INDEX OF SHEETS
SEE SHEET 2

STATE OF TEXAS DEPARTMENT OF TRANSPORTATION

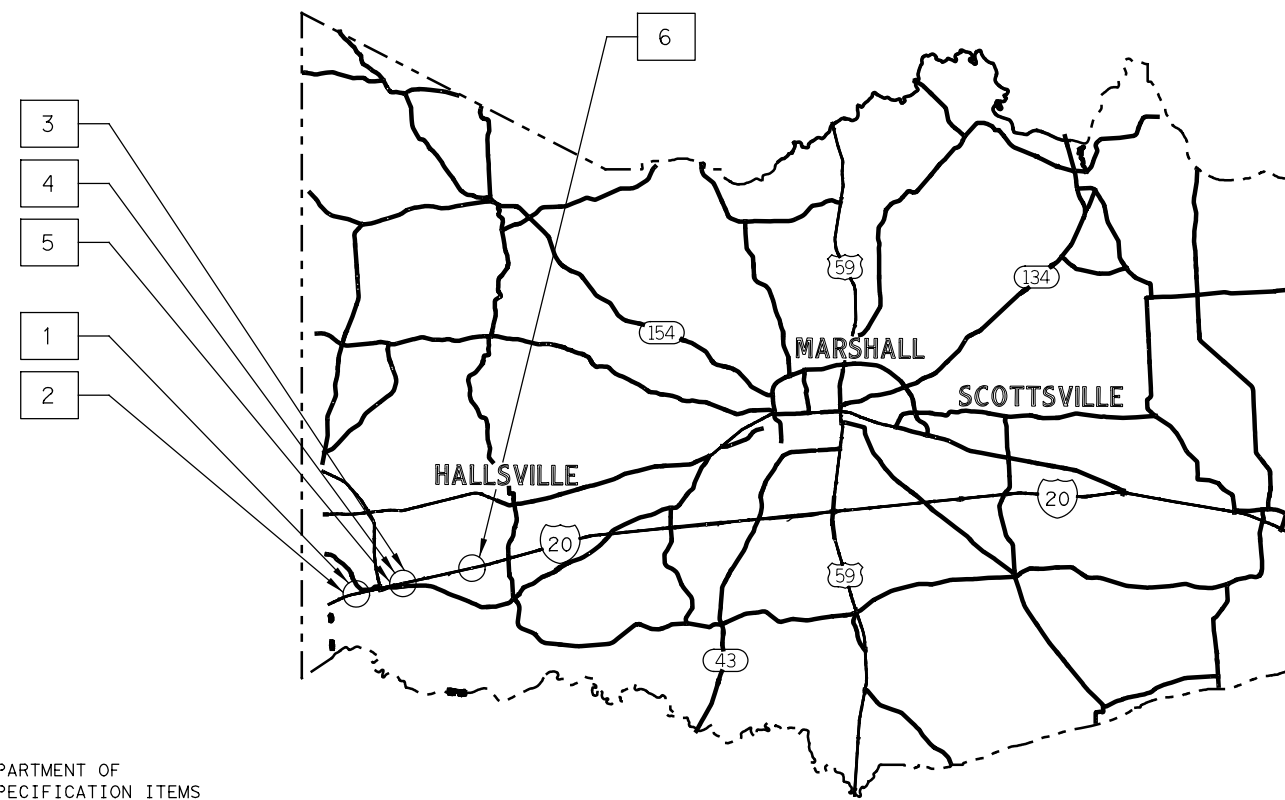
DATE WORK BEGAN: _____
 DATE WORK COMPLETED: _____
 DATE OF ACCEPTANCE: _____
 LIST OF APPROVED FIELD CHANGES: _____
